PALISADES PLANT

**U.S. NUCLEAR
REGULATORY COMMISSION
DOCKET NO. 50-255**

STEAM GENERATOR REPAIR REPORT

**Consumers
Power
Company**

Figure 4.3-3

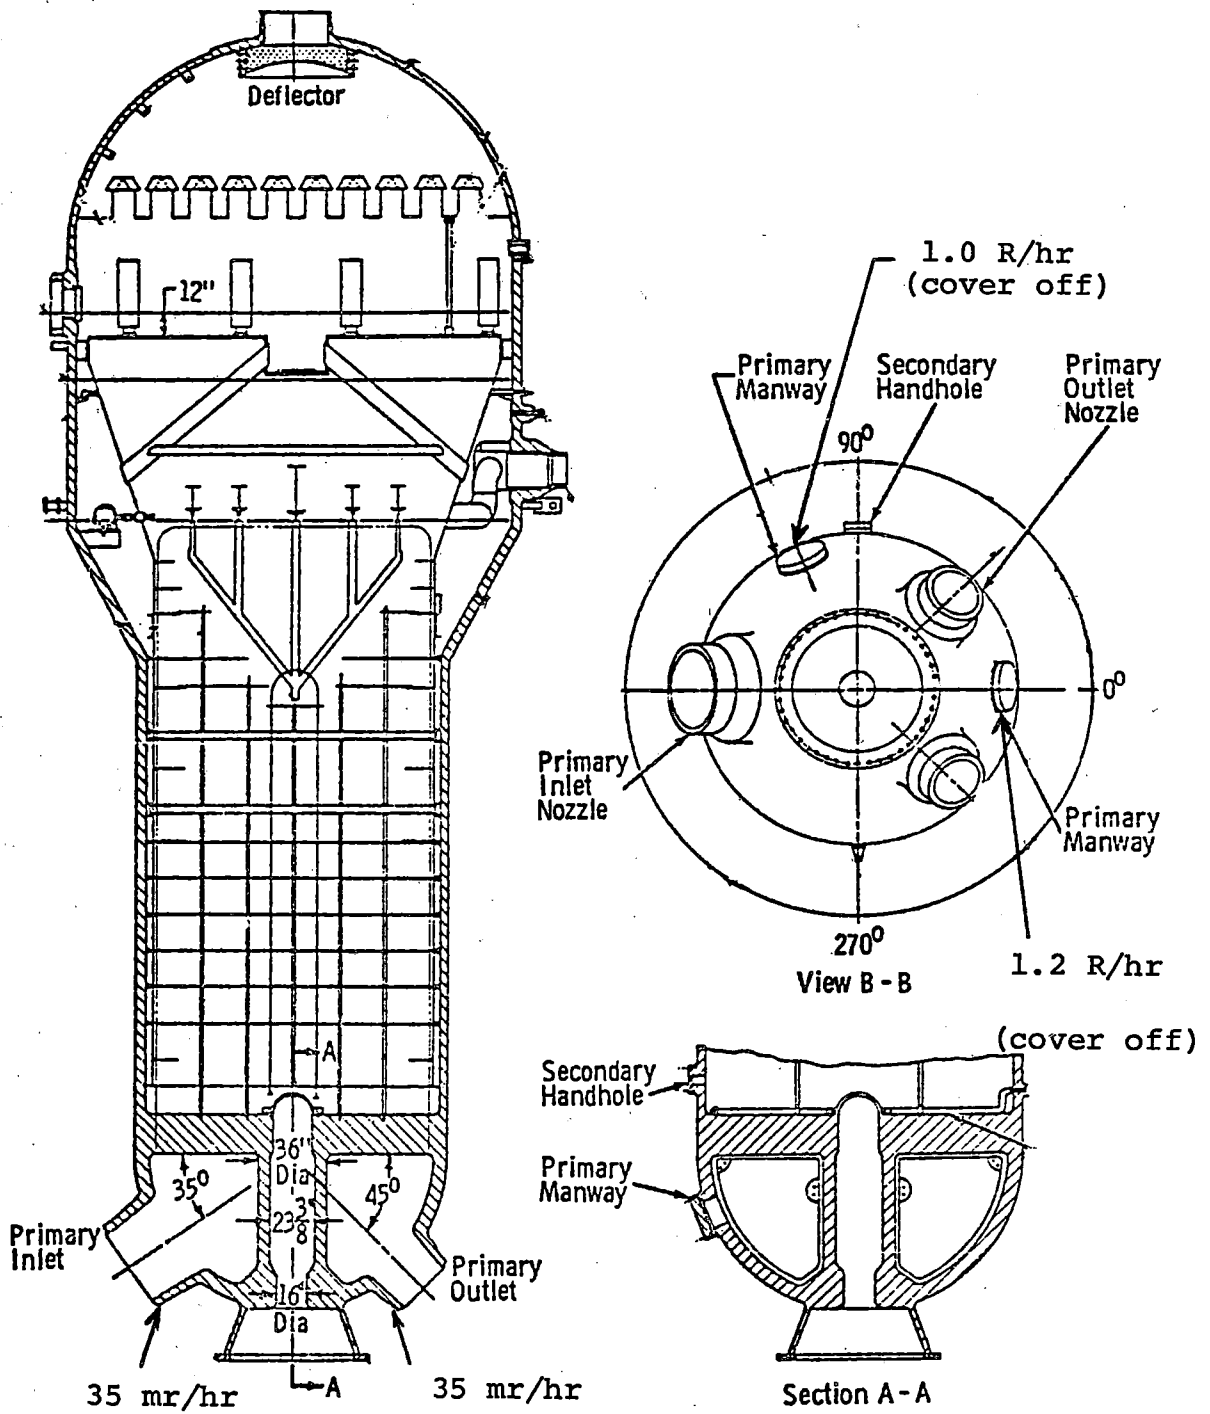
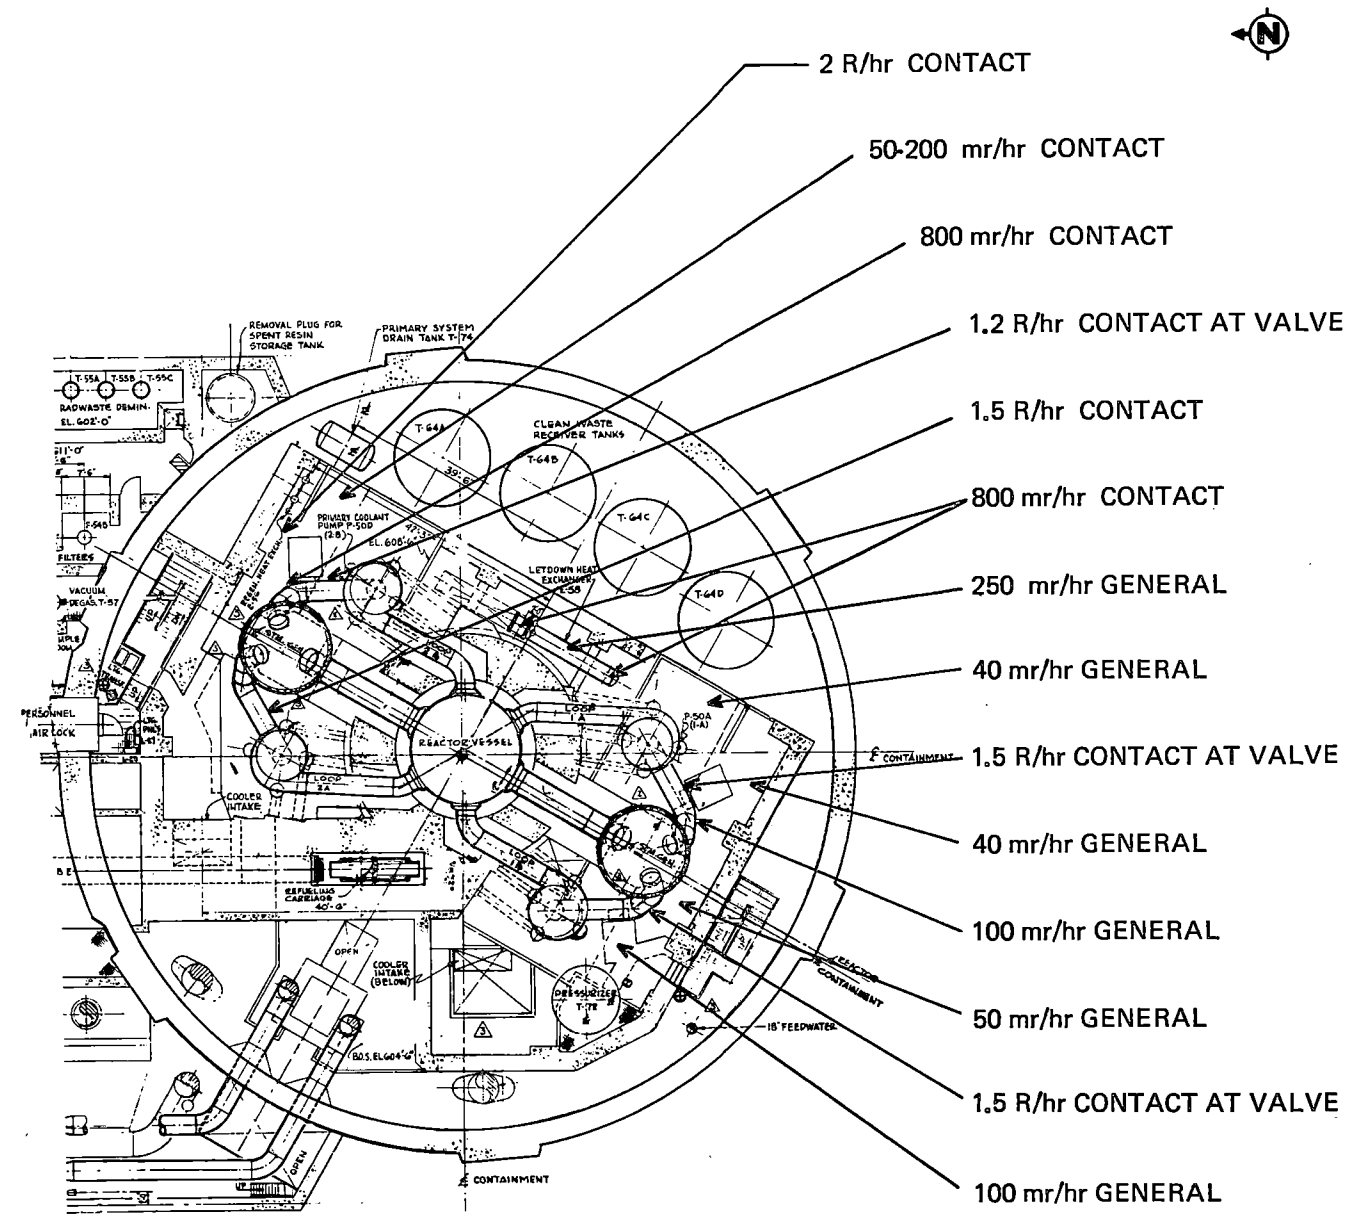
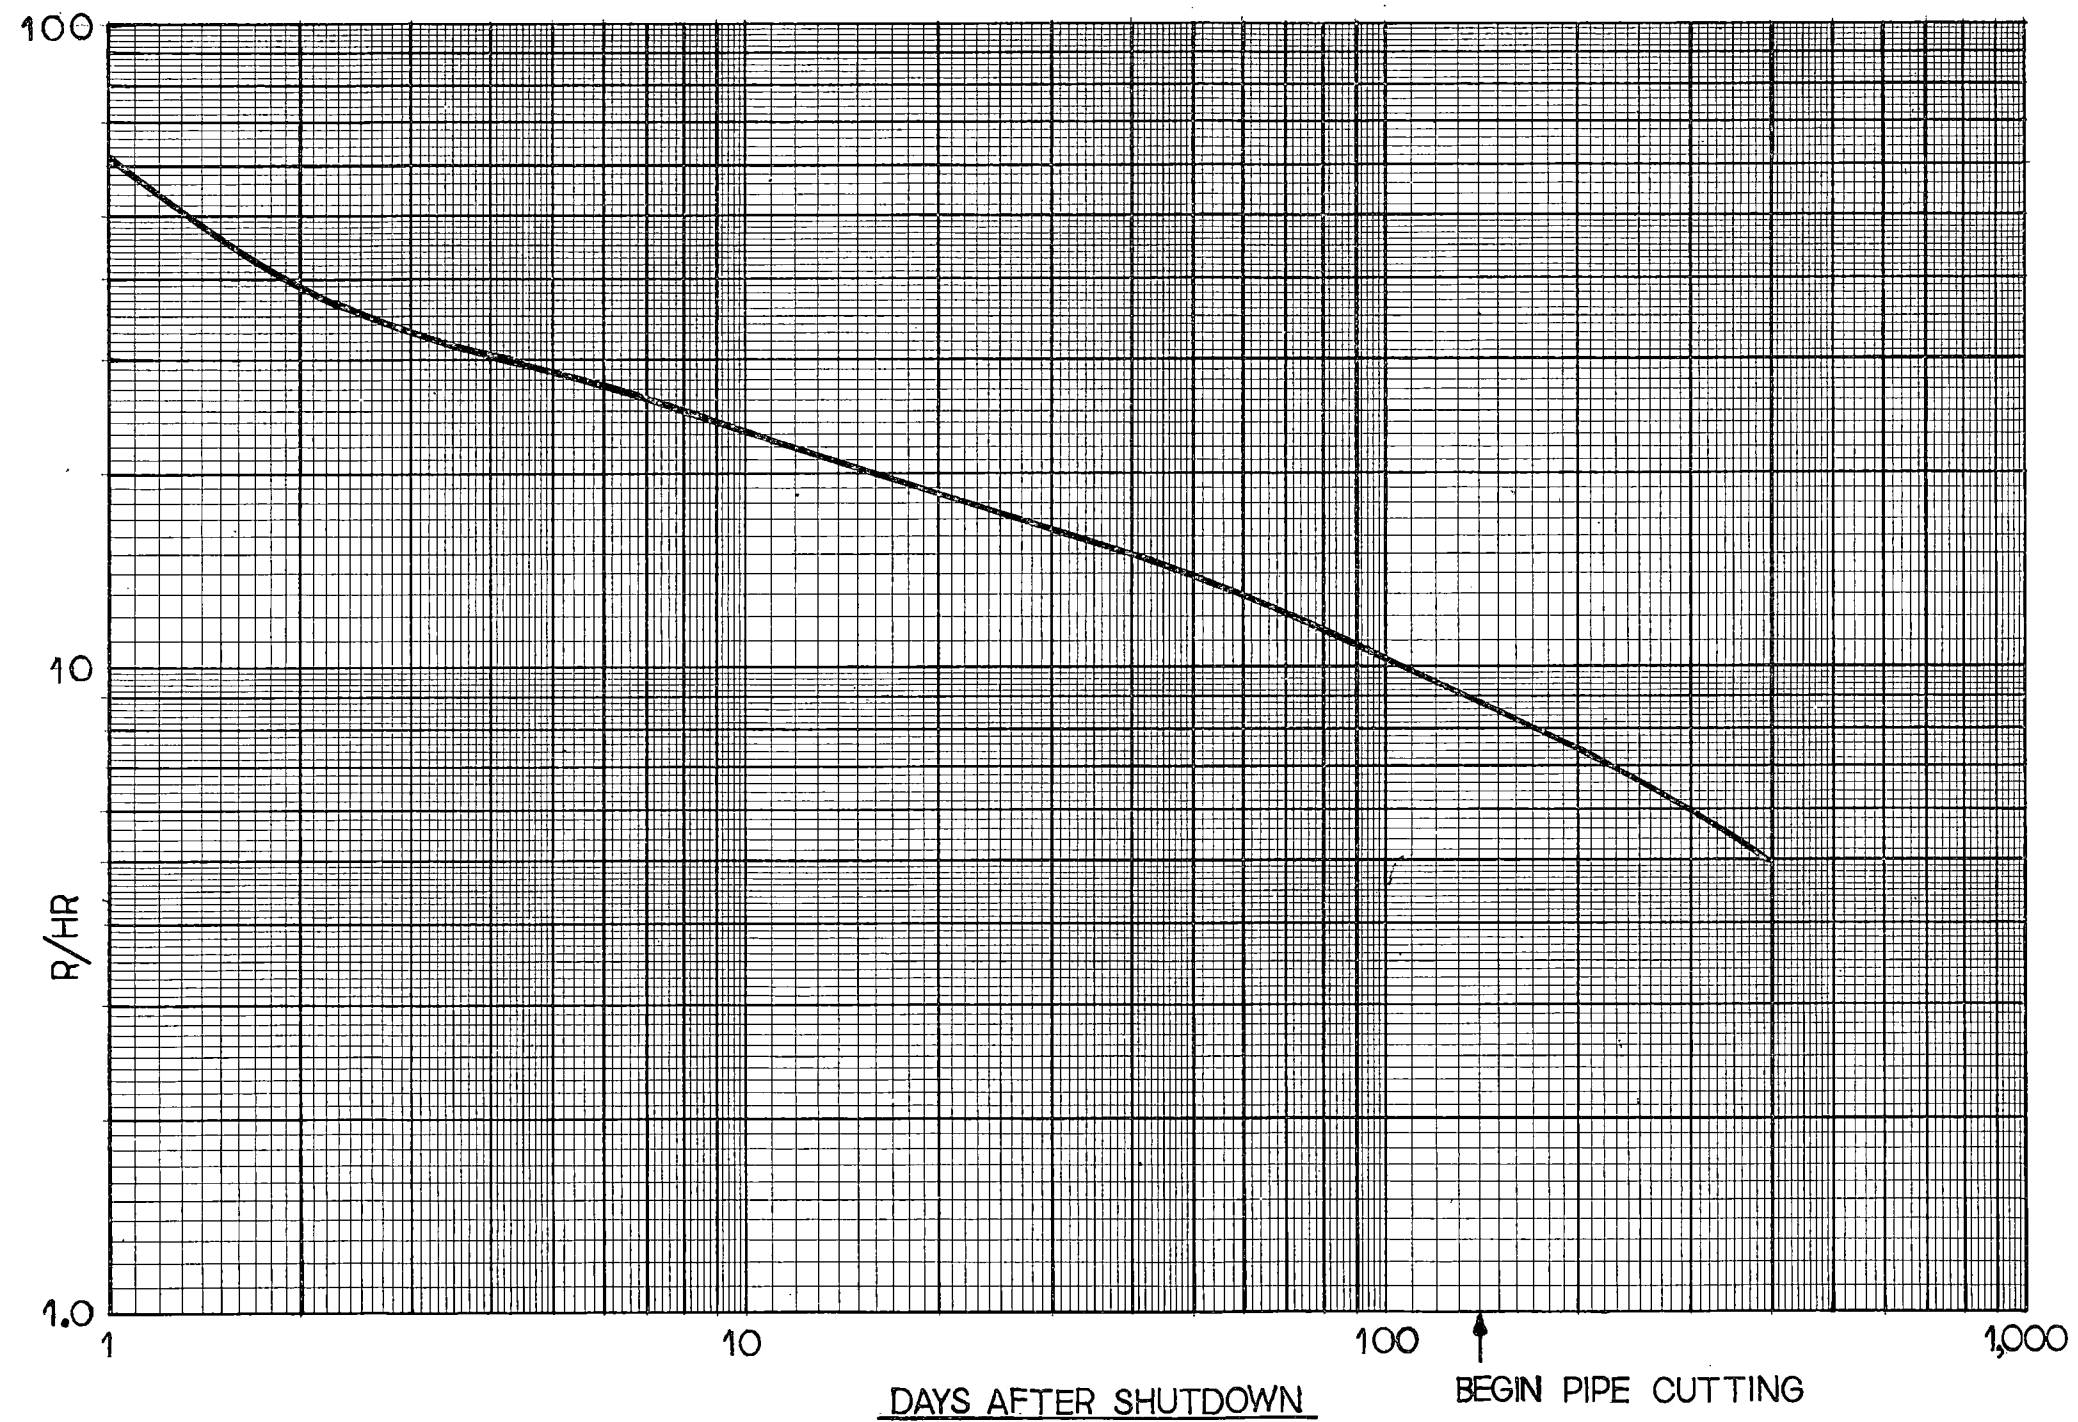
- C-3 Provide a diagram showing the radiation surveys around the steam generator replacement/repair activities. Include similar radiation surveys for Figures 4.2-4 through 4.2-7. Include a table showing the whole body dose received during the inspection and plugging of the degraded steam generator tubes for 1976, 1977, and 1978.

- Figures 4.3-3, 4.3-4, and 4.3-5, which are included in the Steam Generator Repair Report, show radiation surveys around the steam generators at various times after shutdown. The fields specified are representative of those expected for the replacement repair activities. It should be noted that the fields specified in Figure 4.3-5 are expected to decrease significantly at the time that pipe cutting begins, considered to be 42-140 days post-shutdown for study purposes. The decrease will follow the general radiation field near the steam generator piping shown in Figure 4.3-7. Figures 4.2-4 through 4.2-7 have been modified to include general field information in areas where replacement/repair activities will occur and are now designated as Figures C-3-1 through C-3-4.
